Recall Bulletin

F/CMVSS NONCOMPLIANCE RECALL

SUBJECT: Possible Missing Secondary Hood Latch

MODELS: 2010-2012 Chevrolet Colorado
2010-2012 GMC Canyon

3228827

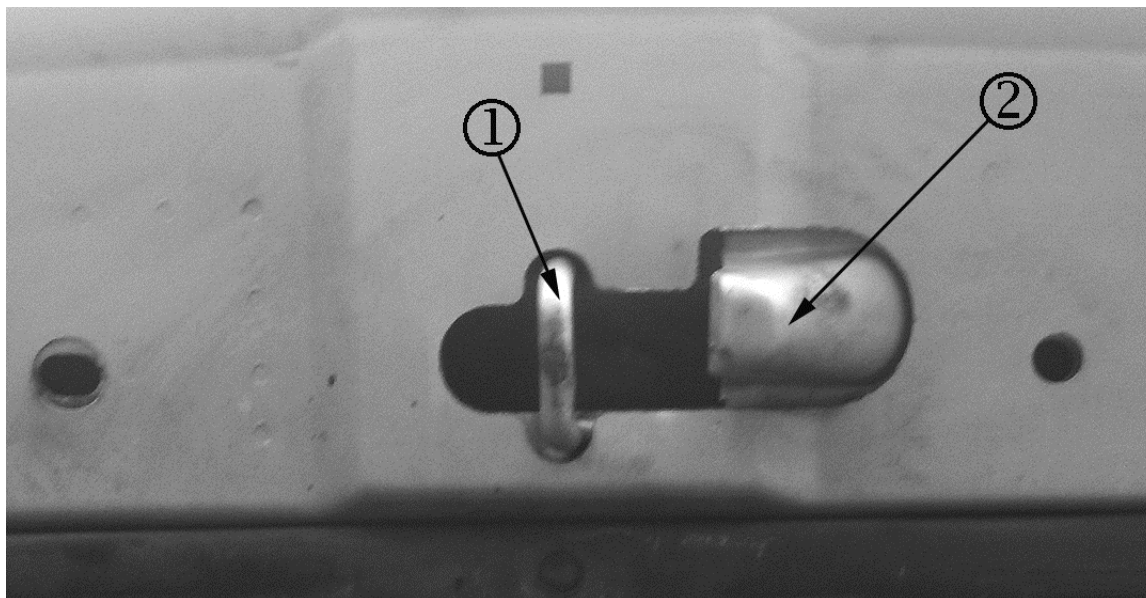
2. Release the hood prop from its retainer and put the hood prop into the slot in the hood (3).
3. Locate the primary (1) and secondary (2) hood latches. Refer to the illustration.

4. Determine if the hood is assembled with a secondary latch (2).
 - If the vehicle hood is assembled with a secondary latch, no further action is required. Lift the hood to relieve pressure on the hood prop. Remove the hood prop from the slot in the hood and return the prop to its retainer. Lower the hood 25 to 30 cm (10 to 12 in) above the vehicle and release it to latch fully. Check to make sure the hood is closed and repeat the procedure if necessary.
 - If the vehicle hood is NOT assembled with a secondary latch, remove and replace the hood. Refer to *Hood Replacement* in SI for hood removal and installation instructions.
